REMARKS

Amendments to the Drawings

FIG. 1

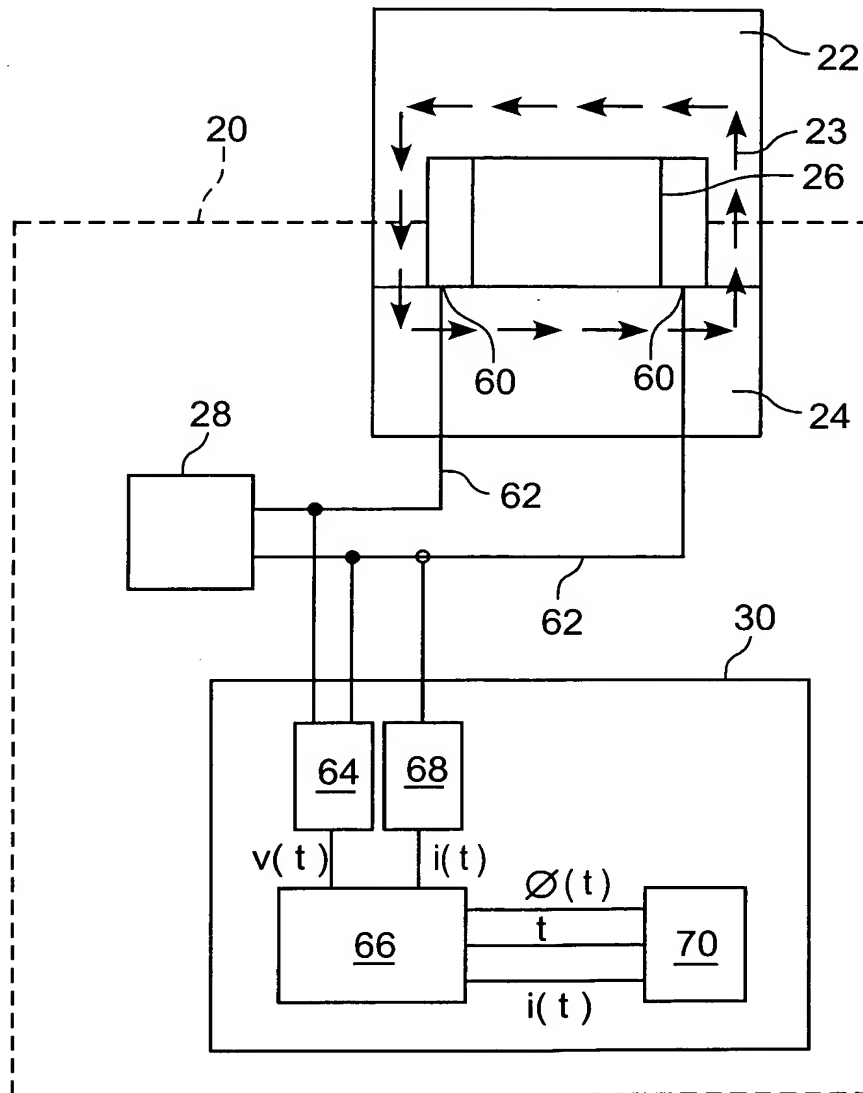
The drawings are objected to because 1) items (22) and (24) appear to point to the same thing in FIG. 1, 2) the difference between (22) and (24) in Fig. 2 is not clear, and 3) item (60) in FIGS. 2-5 is not mentioned in the specification. The drawings are also objected to under 37 CFR § 1.83(a) because they do not show “the flux coil leads coupling the flux coil to the monitoring device” as recited in claim 17.

Regarding item 1), applicants have attached hereto an annotated sheet showing changes (in red) made to FIG. 1. In FIG. 1, a horizontal line has been added through the item labeled (22) and (24) to distinguish item (22) (the magnetic component) from item (24) (the flux path closure device). This horizontal line is positioned relative to items (22) and (24) in a manner that is consistent with existing FIGS. 2-5. No new matter has been added by this change to FIG. 1. Applicants have also attached hereto a replacement sheet that replaces original drawing page 1 showing FIG. 1.

1. A replacement sheet for FIG. 1. This sheet replaces original page 1 of 10 of applicants' drawings.
2. An annotated sheet showing changes made to FIG. 1 in red. In the replacement and annotated sheets for FIG. 1, a horizontal line was added, consistent with FIGS. 2-5, to clearly separate components (22) and (24).
3. A replacement sheet for FIG. 2. This sheet replaces original page 2 of 10 of applicants' drawings.
4. An annotated sheet showing changes made to FIG. 2 in red. In the replacement and annotated sheets for FIG. 2, the original reference number (24) and its associated connecting line have been deleted, and the reference number (20) located just above "FIG. 2" has been changed to (24). This resulting designation of items (22) and (24) is consistent with FIGS. 3-5.
